SUBJECT: Data Request No. 6 for the San Joaquin Cross Valley Loop Project (A.08-05-039)

Data Request #6

San Joaquin Cross Valley Loop Project

Figure 2-3
Proposed Project and Alternatives

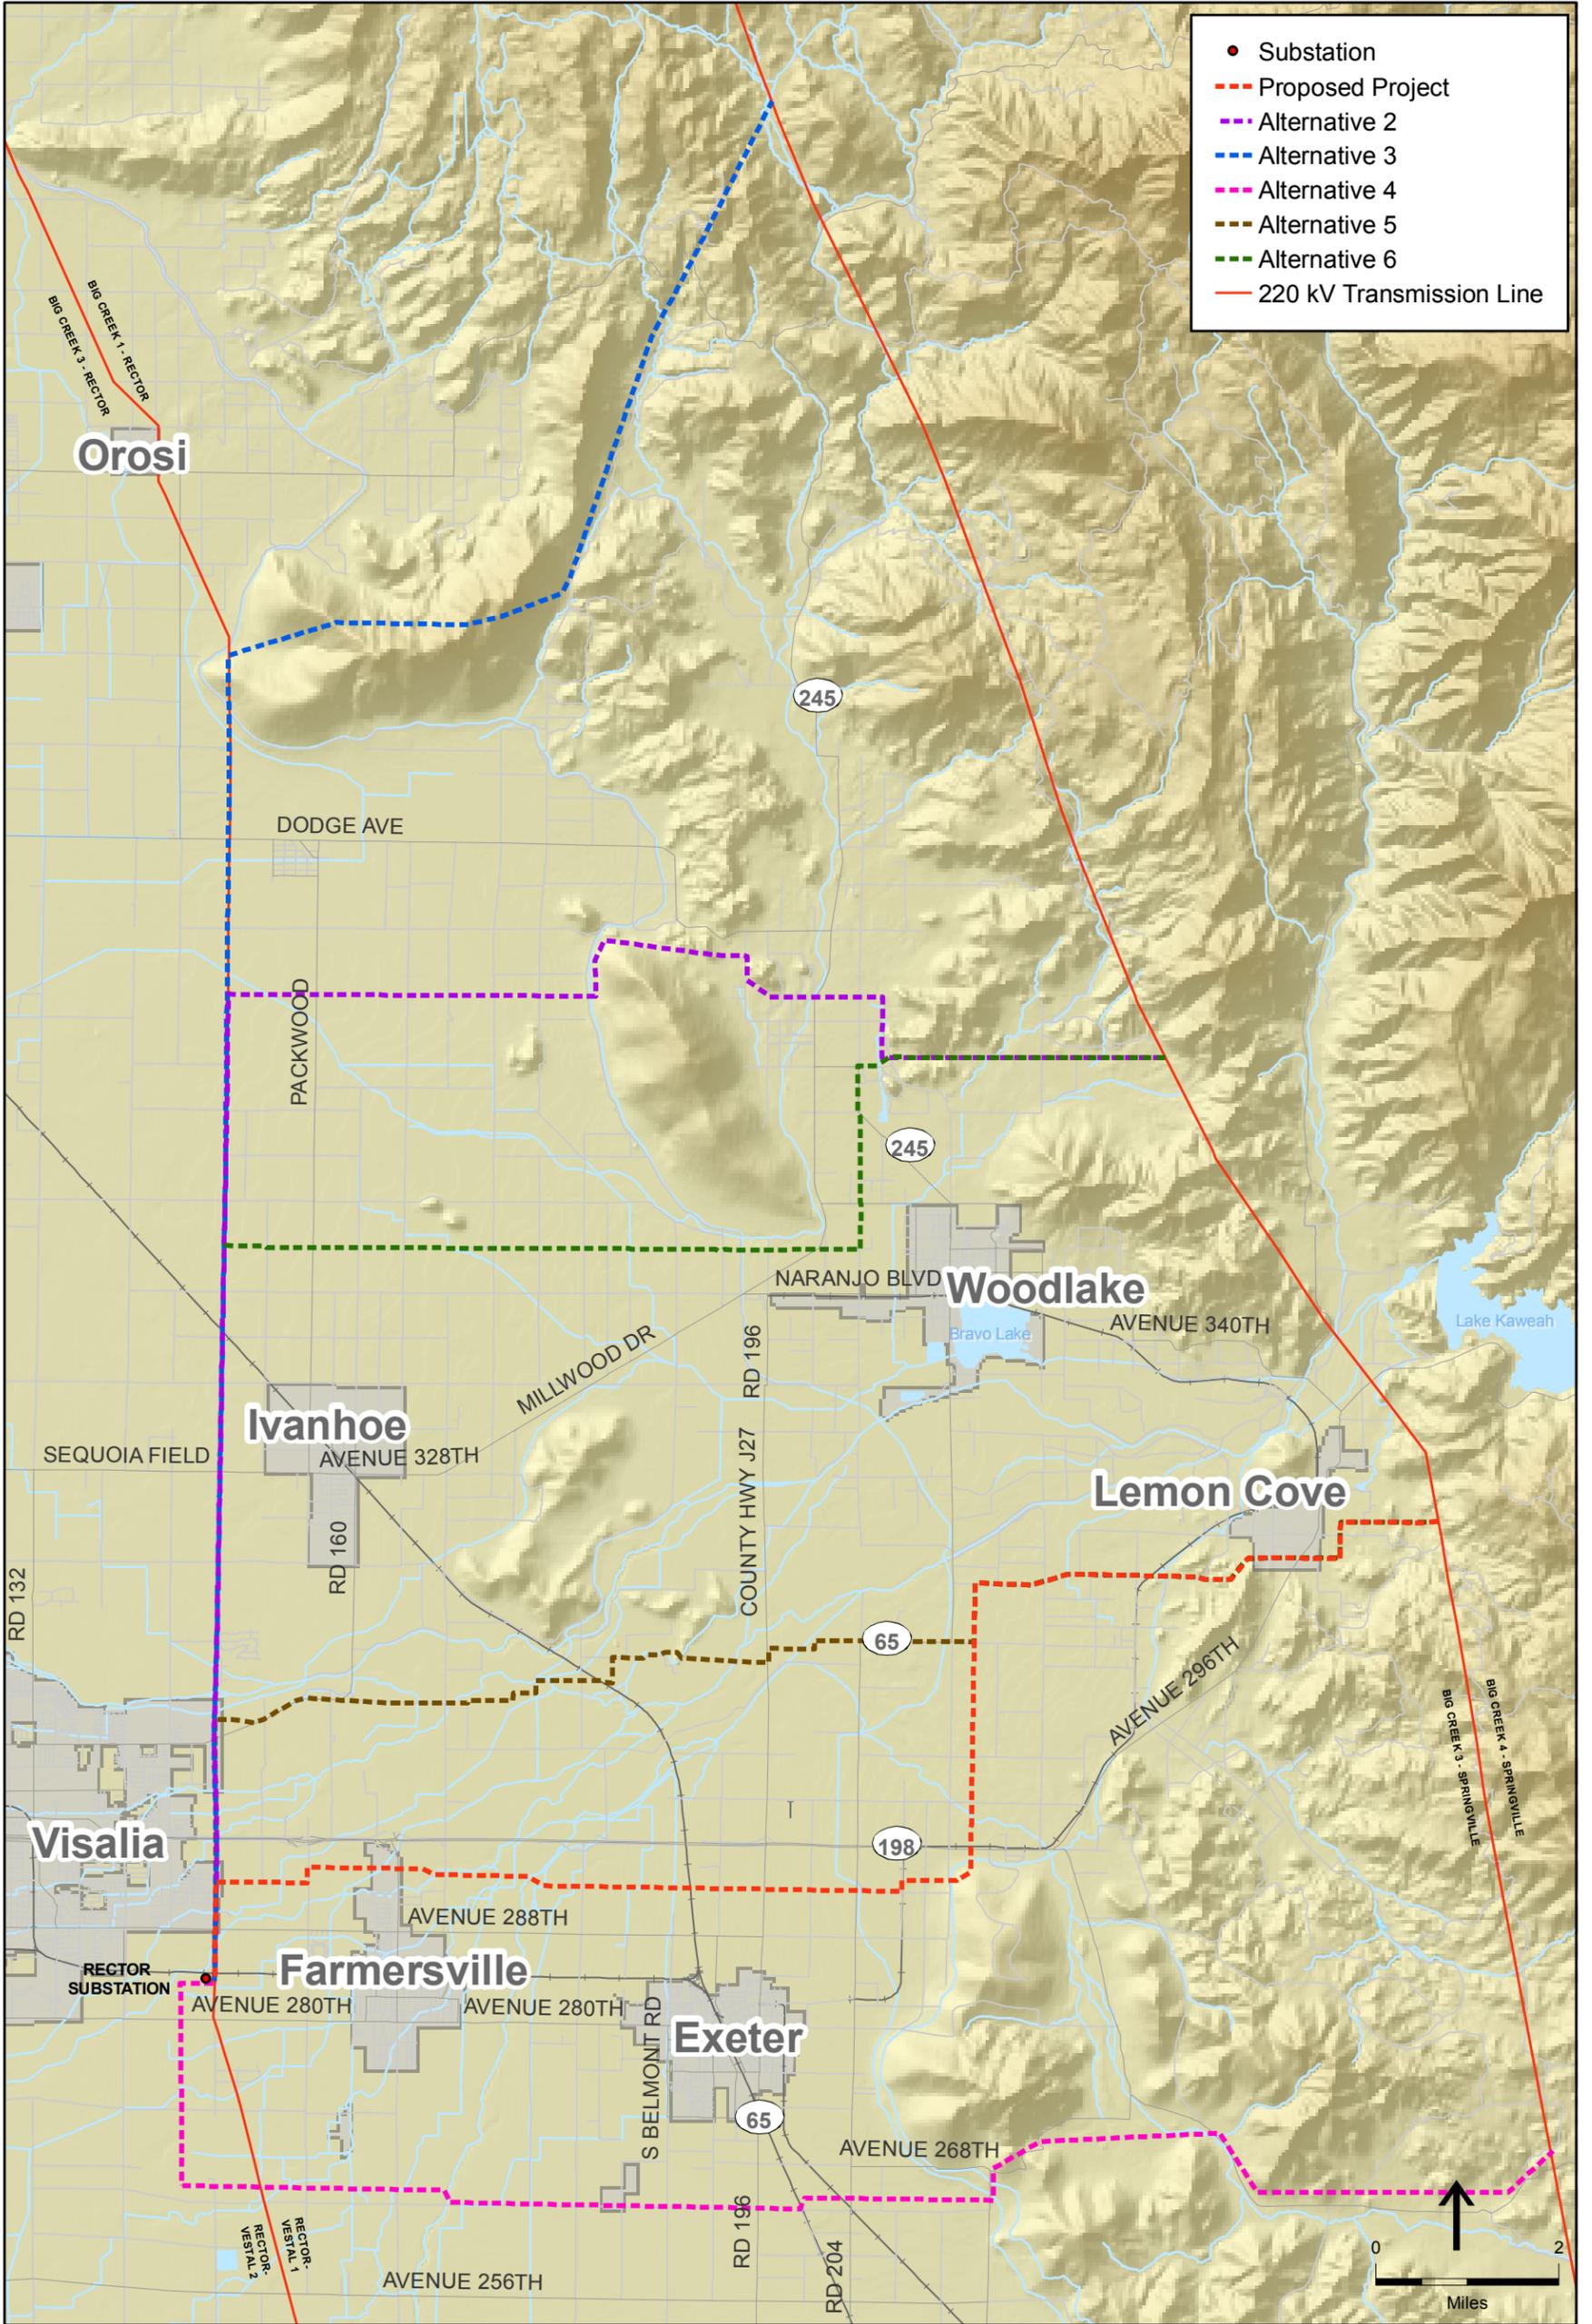
6. Please clarify inconsistencies in the crop data submitted to ESA electronically on 01/27/09. For the polygon within the existing ROW near where Alternative 1 begins to traverse east, the data for Alternative 2 delineates walnuts in the eastern half of the ROW, while Alternative 3 data delineates walnuts in the entire ROW, please revise. Additionally, the walnuts mapped just north of the 2 mile marker for Alternative 2 were not included in the Alternative 3 data, please revise.
